modified type plans for adoption to build
lock-ups in connection with the
construction of a new lockup building at
Sagar.

Modified type plan for adoption to build lockup in connection with the Construction of a new lockup building at Sagar

Type design for Taluk Lock-ups in the State.

— MODIFIED TYPE DESIGN —

PLAN OF TALUK LOCK-UP.

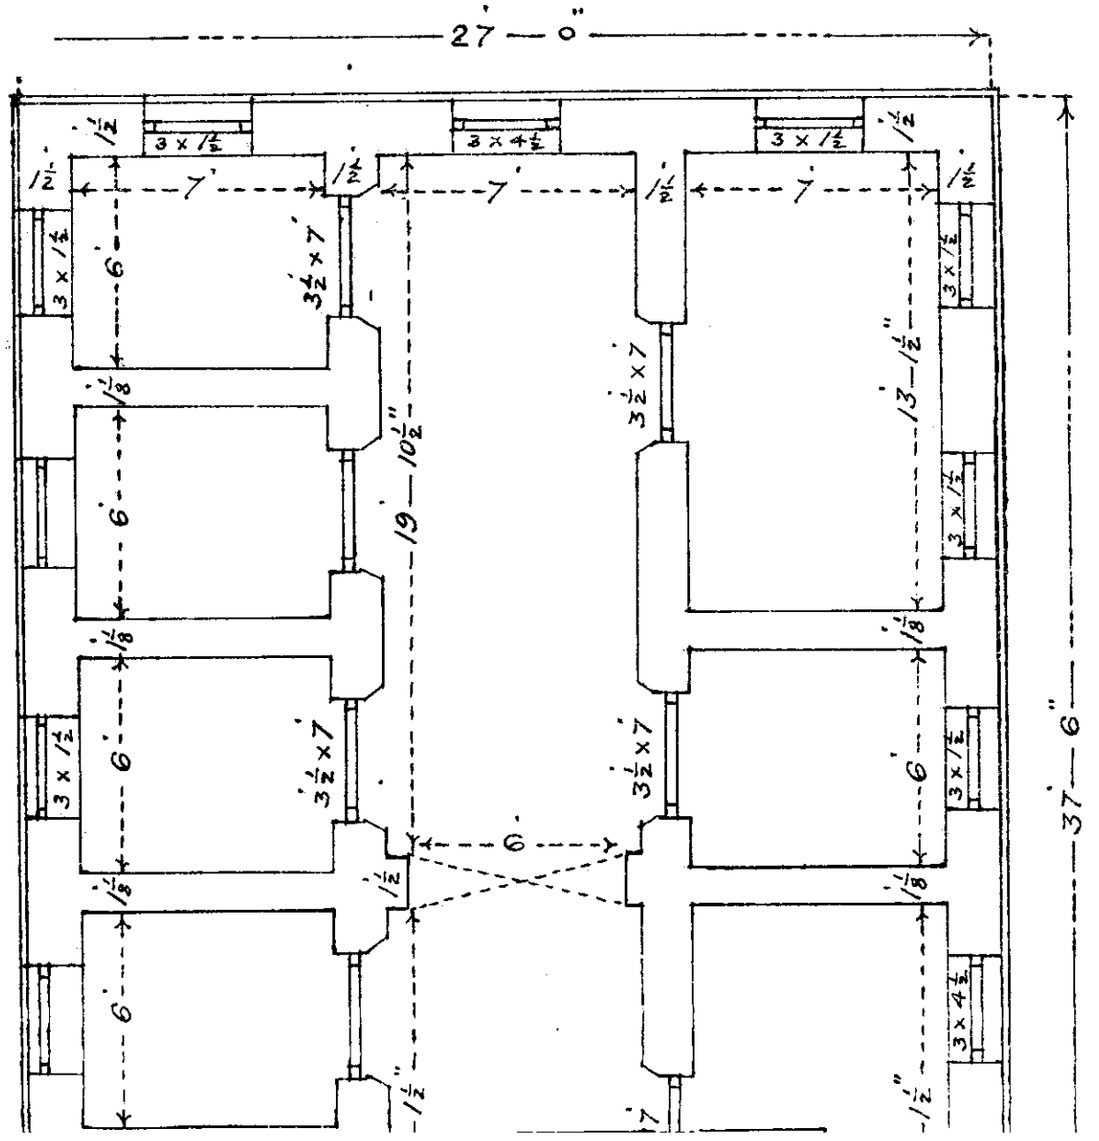
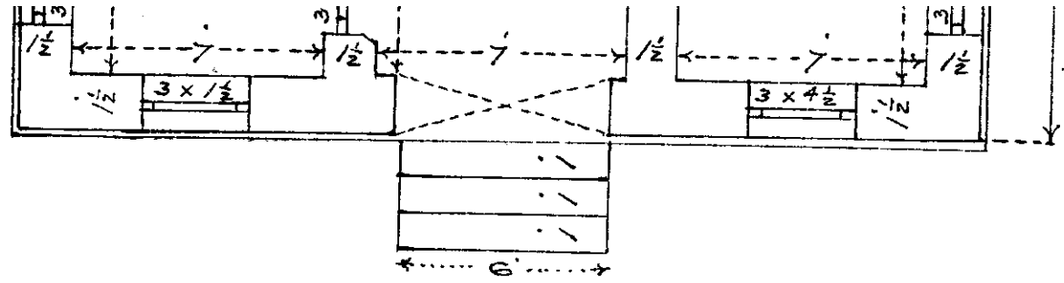
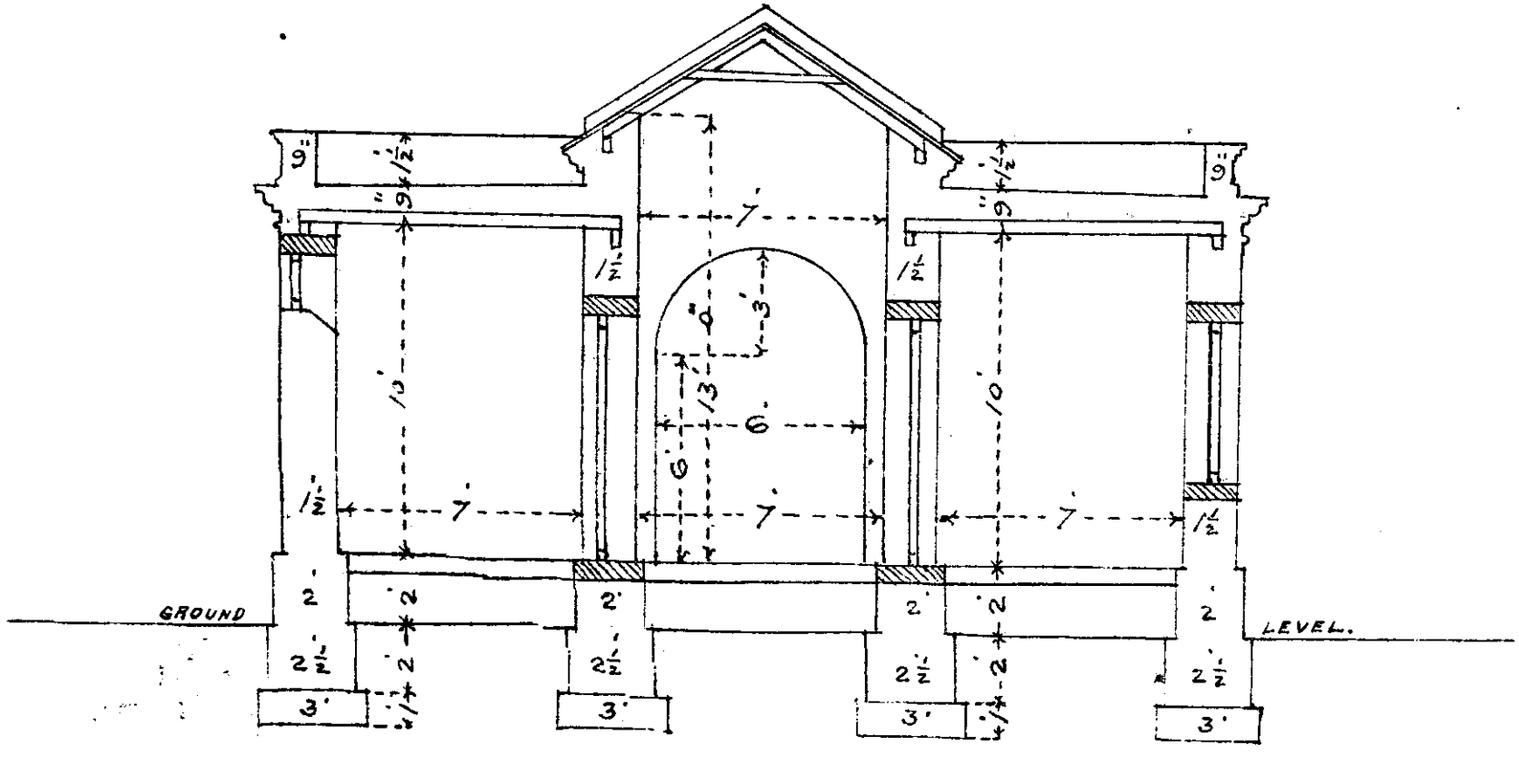
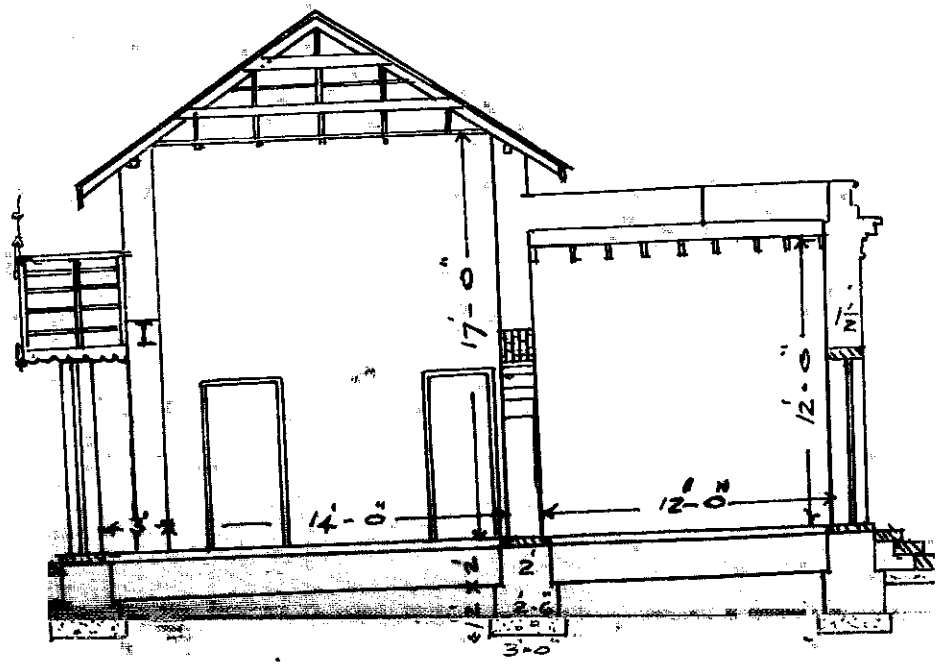
With reference to your letter No. 394/31-25 dated the 18th February 1926 calling for expression of my opinion on the several type designs for the construction of Taluk Lock-up buildings in the State, I have the honour to observe as follows:-

(1) The Lock-up buildings to be constructed in the State as per type plan now under contemplation are required in connection with the establishment of the Special Magistrate's Court under the recently sanctioned scheme for the separation of the - judicial and the executive functions in the State.

The new Lock-up buildings therefore are to supplement the existing cell accommodation in the Taluk Office buildings in the different parts and cannot therefore be compared with the designs for similar buildings in British India where the the Lock-ups are constructed as Sub Jails and form an integral part of the Taluk Office building.

(2) The determination of the size of the individual cells, however, is the only point that has to be taken up while comparing the designs before us. Each cells measures 12' 0" x 8' 6" in Sub Jails in Madras while the size noted in the type plan under reference measures 12' x 10' and this size has been proposed by this Office as the cell has to be used both as living and dining room by day and as bed room at nights. You yourself have opined that cells measuring 7' x 6' as provided for in the existing type design are too small for human habitation.

(3) Again, the arrangement of rooms in the type plan now proposed is such as to admit of construction of cells of any number from two to six according to the requirements of different localities in the State, so that if ~~any~~ in any particular place only 2 or 3 cells are considered to be sufficient to serve the immediate needs, a smaller building may be put up and this may easily be extended to contain 6 cells later on if necessity arises; but as these cells are to be constructed independently of the Taluk Office, these are built round a central Hall which is required for the accommodation of the sentry and the police staff on duty to watch over the under-trial prisoners. For this reason this hall will serve the purpose better than the long corridor as shown in the existing type plan.

2. For reasons given above and also because the plan now recommended is the most economical design that can be made up for the required accommodation and to fulfil the conditions for a proper Jail building, I recommend that the same may be adopted in preference to the existing type plan, the size of the cells may, however, be - reduced to 12' x 8½' if in your opinion this is considered sufficient instead of 12' x 10' as recommended by you sometime back.

I am of opinion therefore that the plan proposed by the Chief Engineer may be adopted.

PLAN OF A SUBSIDIARY ANNEXED TO A DEPUTY TAHSILDAR'S OFFICE.

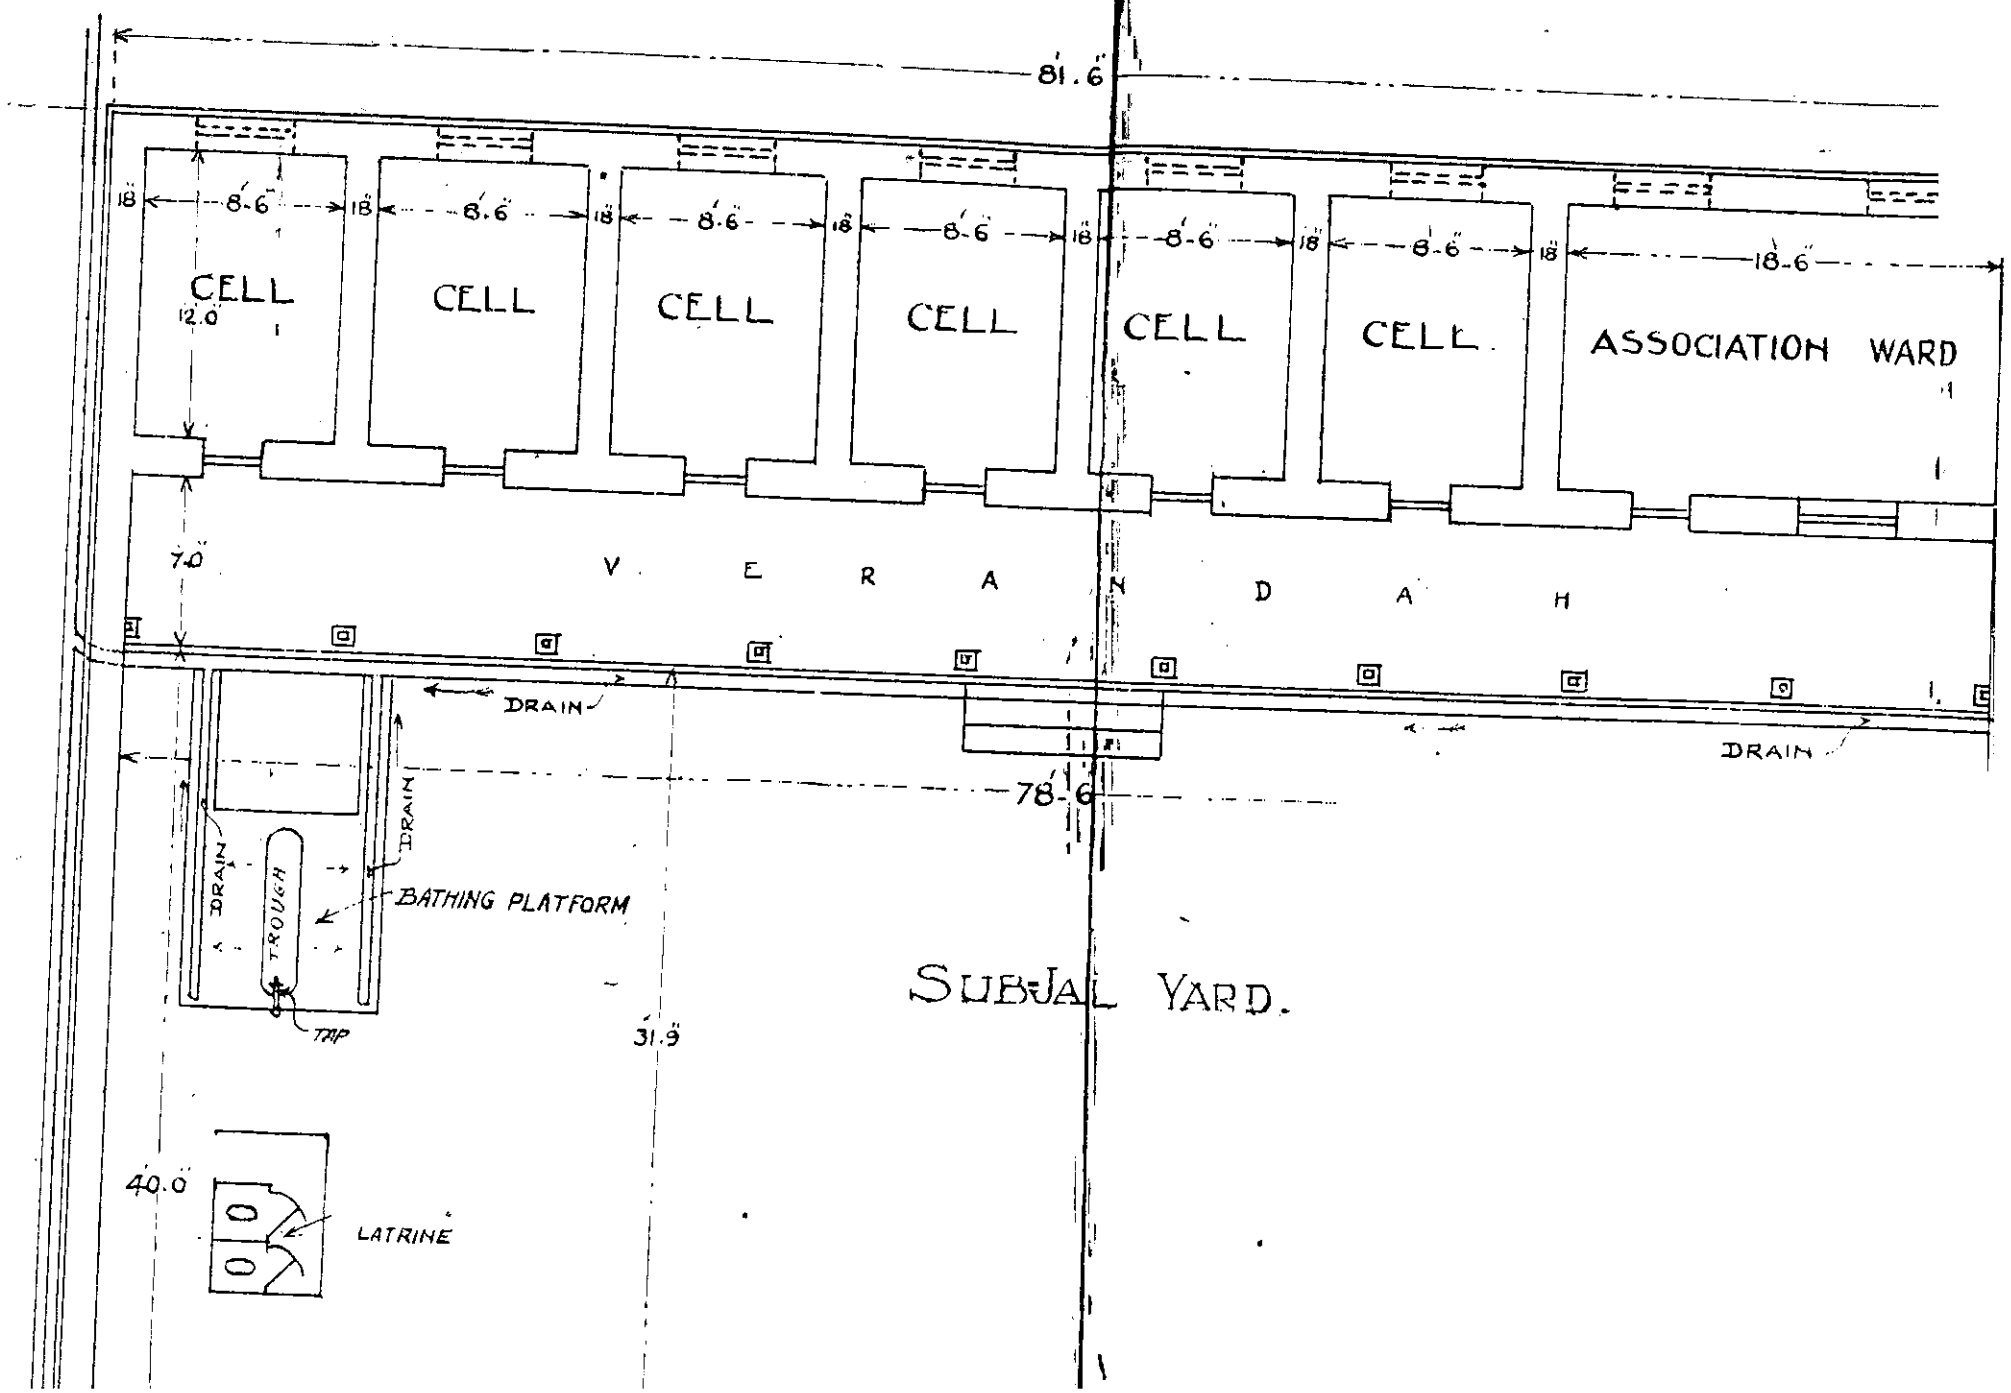
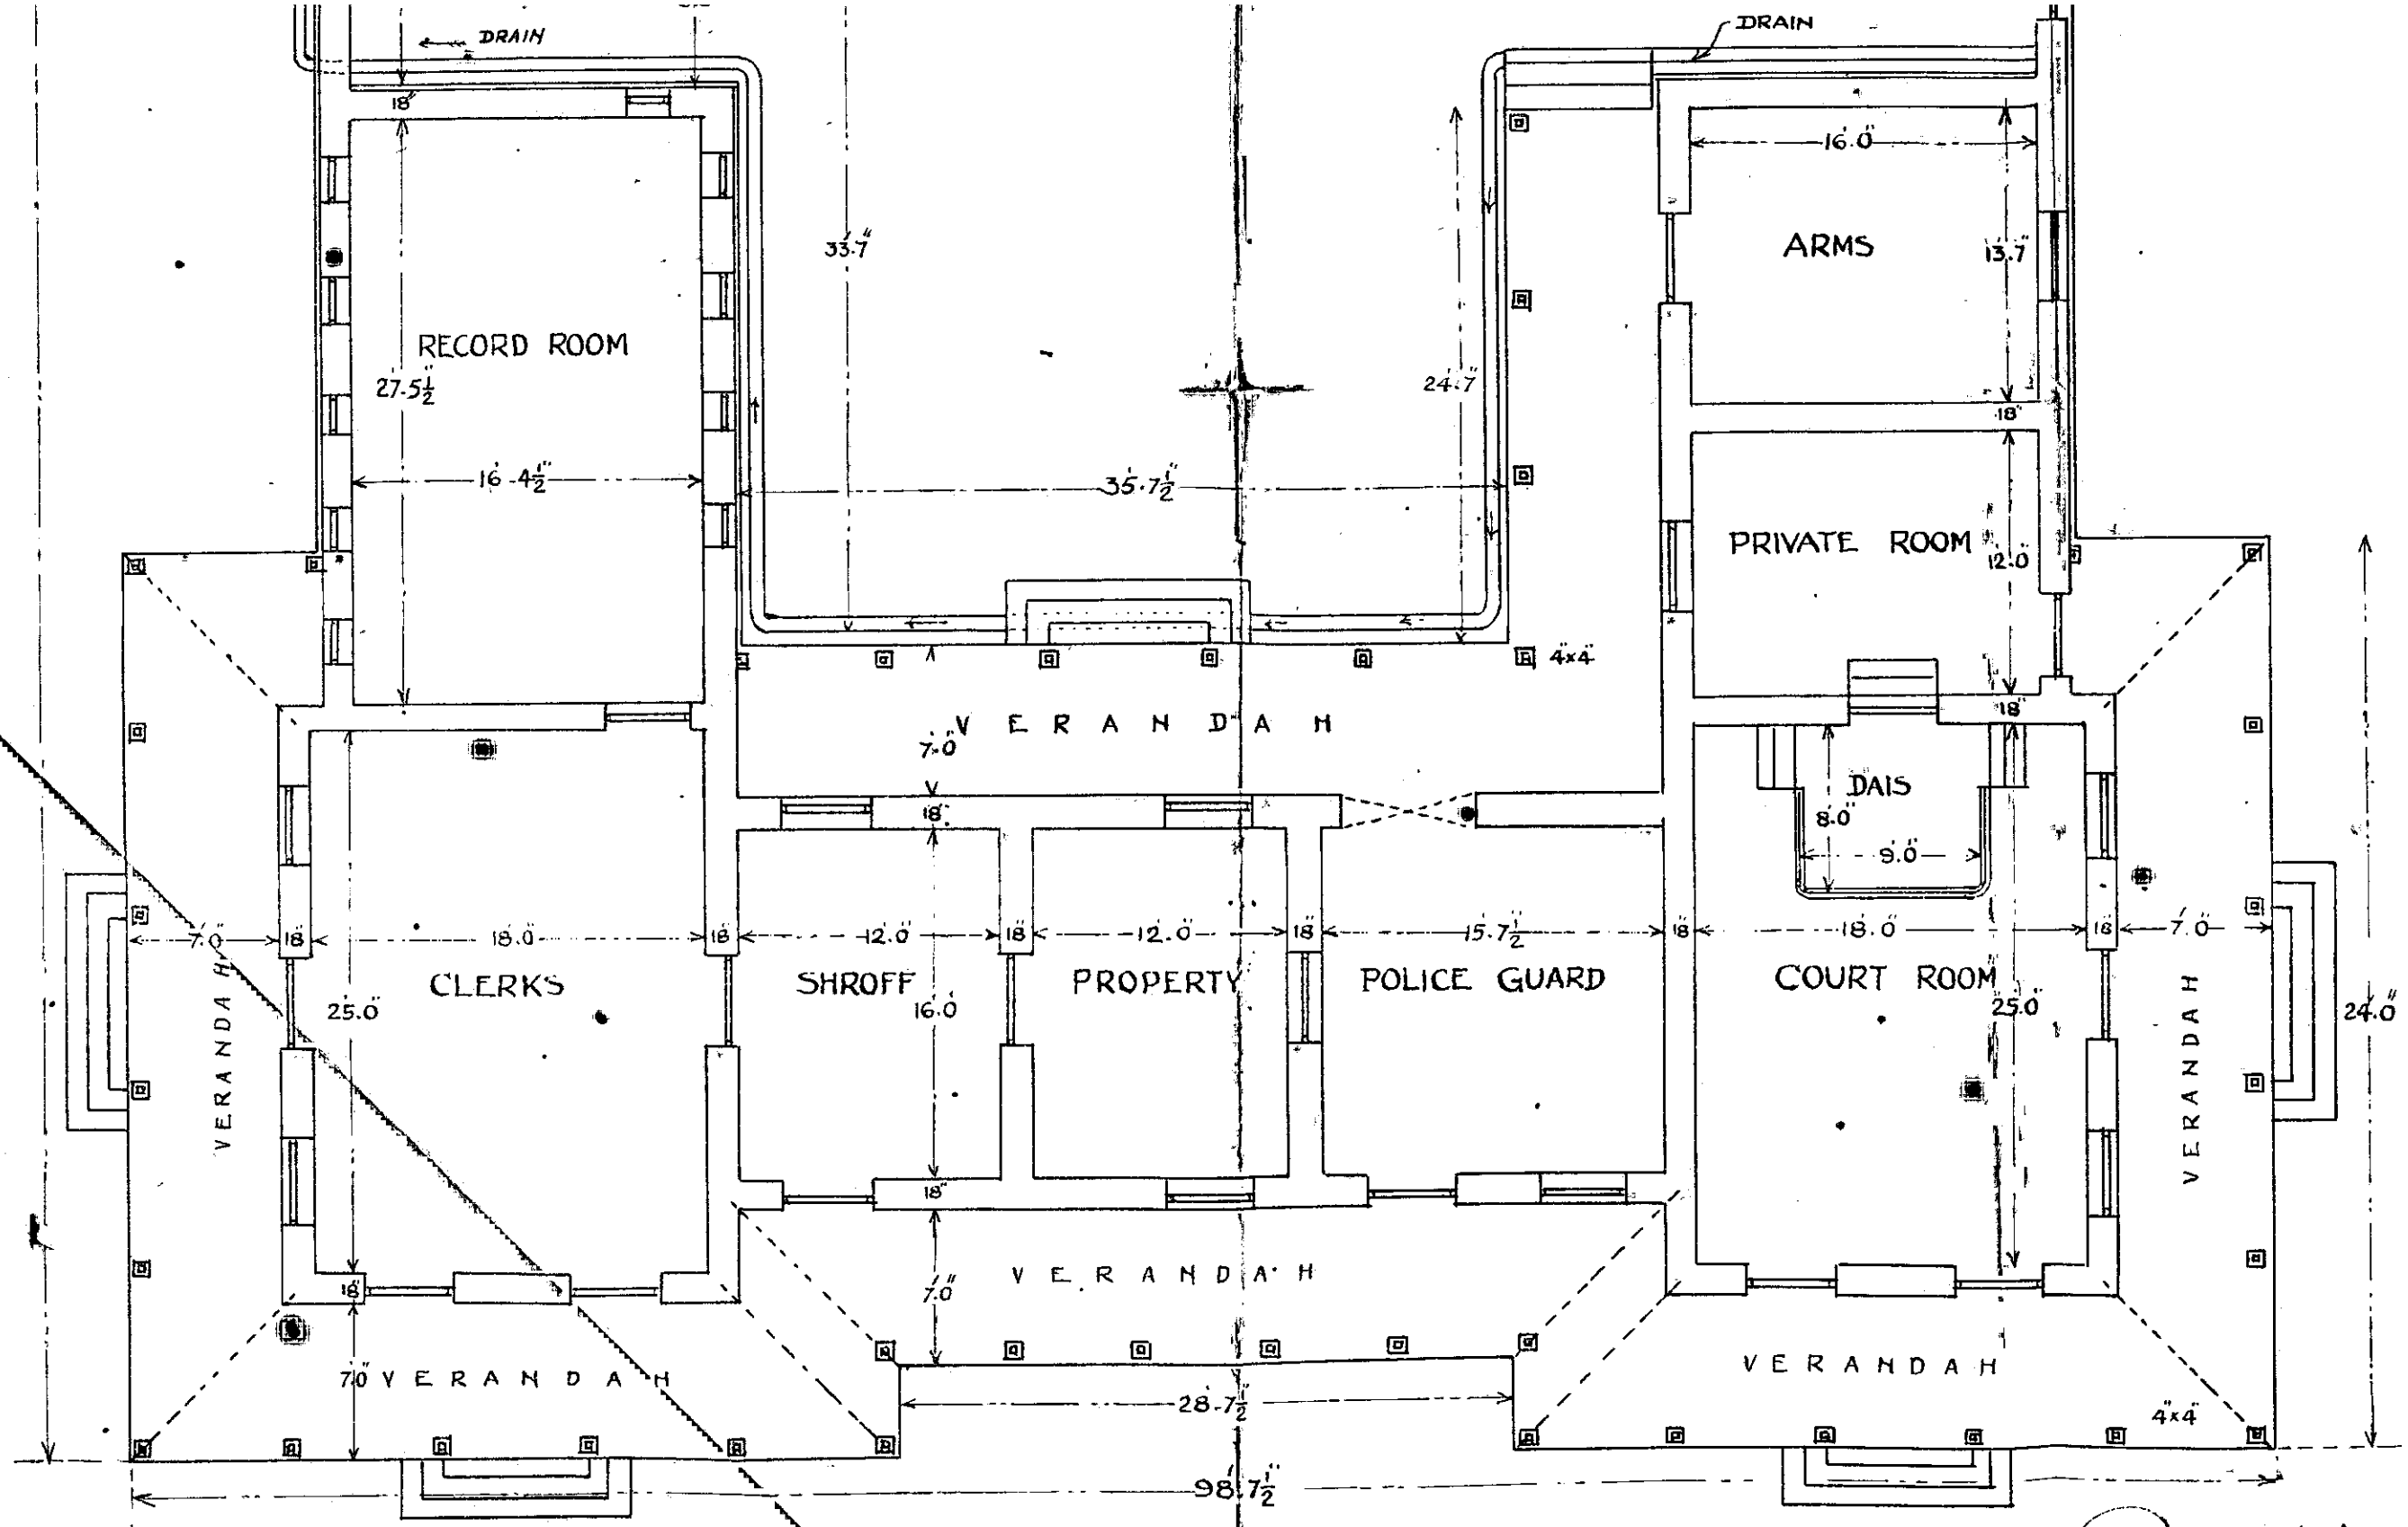
13) The Madras model, the accommodation provided there is almost the same as in Nagpur viz 6 cells, and the whole block is attached to the Taluka office as part and parcel of it; and even in Nagpur, where new type design Taluka offices exist, this sort of lock-up arrangement prevails e.g. Tantkere, Kundalpur &c, except that kitchen & latrines are outside the building but in the Cutchery compound, and therefore the Madras plan does not appear to be a decided improvement whatever over our plan.

17) The plan of the Sub-Jail is too elaborate & will not do for our taluk lock-ups. The other plan of a subsidiary Jail attached to a Tahsildar's Office suits our requirements, as latterly, at any rate, a taluk office is built so as to contain a lock-up also. The plan sent up by the Dy for Jaggar and for approval as a model for taluk lock-up is a separate lock-up unconnected with the taluk office. So far as guarding the jail is not so efficient as a lock-up attached to the office itself. It is better to consult the Dy Peons as to the relative merits of the plans sent for him as a model for
